Designer	brandon3055	
Created	2022-08-24	
Last Edited	2022-09-23	
Version	v1 2	(

emonMicro

V1.1 - First Build (It Works!!!)

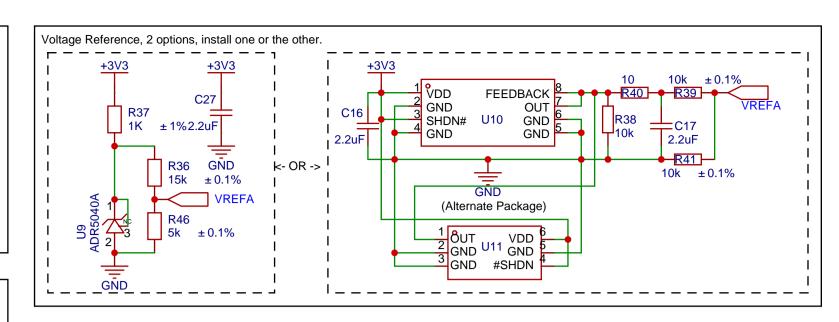
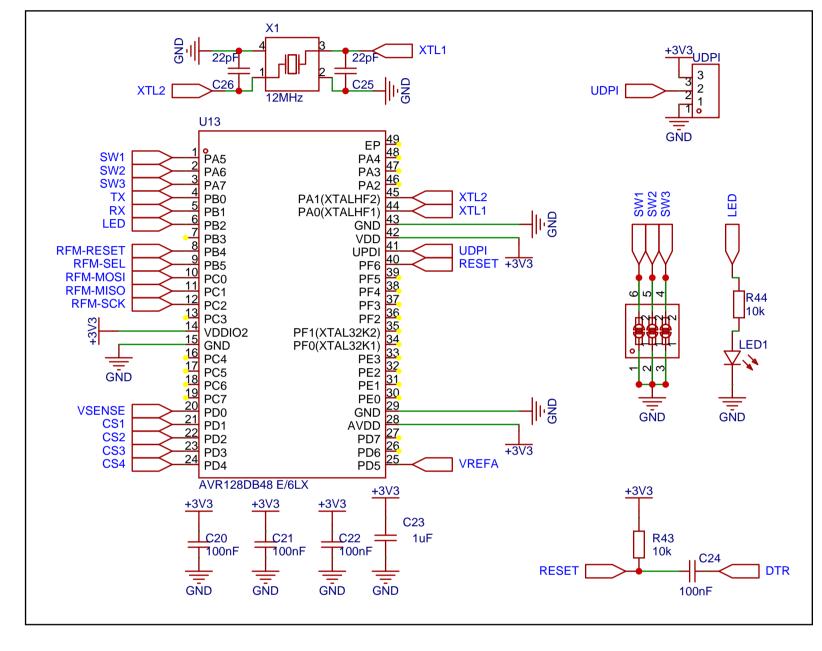
- Switched to differential current applifier configuration

- Fixed reversed FTDI TX/RX pins and names now make more sense

- Fixed copper region connection to shunt resistors

- Adjusted current gain from 8 to 6 (Previous gain forgot to account for RMS conversion)
  Removed analog pin protection (I dont think its required with this topology)
- Added reset line for RFM module
